**FACILITY COMPLIANCE INSPECTION REPORT**  
**Division of Waste Management**  
**Solid Waste Section**

<b>UNIT TYPE:</b>												
Lined MSWLF		LCID		YW		Transfer		Compost		SLAS	<b>X</b>	<b>COUNTY: Pitt</b> <b>PERMIT NO.: SLAS-74-18</b> <b>FILE TYPE: COMPLIANCE</b>
Closed MSWLF		HHW		White goods		Incineration		T&P		FIRM		
CDLF		Tire T&P / Collection		Tire Monofill		Industrial Landfill		DEMO		SDTF

**Date of Site Inspection:** 11/19/2014    **Date of Last Inspection:** 8/29/2014

*Jamey Way  
 Tarboro Septic Tank NC LLC  
 211 Barrington Dr.  
 Tarboro, NC 27886*

Septage applied outside of the permitted boundary.

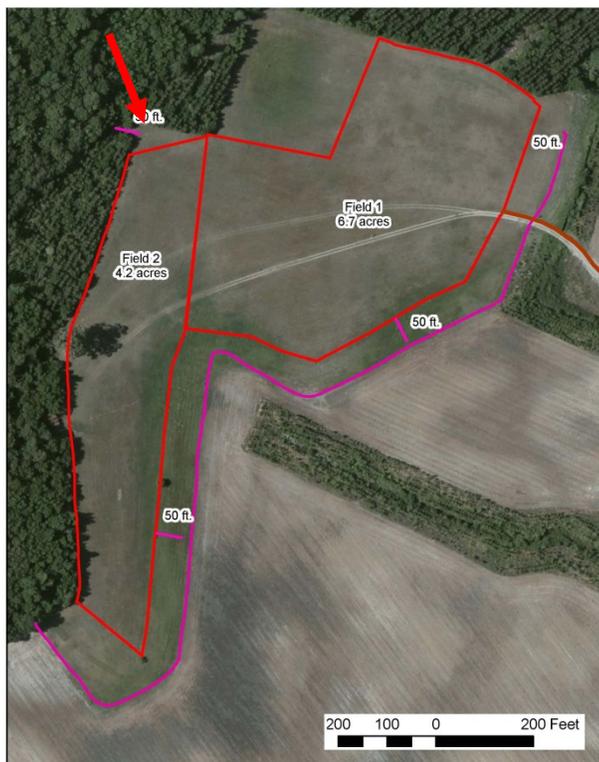
1. Sign for the septage land application site had been knocked down. Need to place sign back up.
2. Access road in good shape.
3. Markers present.
4. Septage outside of the border along the northwest corner of Field 2. See pictures below.

- 1) There is no evidence that the small grain has been planted. This is a violation of Rule .0838(a)(18) that states "Approved nutrient management plans shall be followed." Your nutrient management plan has that the fields will be overseeded with rye (small grain) between September and early November of each year.
- 2) Septage had been applied outside of the northwest corner of Field 2. This is a violation of Rule .0838(a) that states "All septage discharges, including aerial drift from discharges, shall be made within the permitted boundaries of the land application site." Need to insure that all septage discharges are within the permitted boundaries of the two fields.
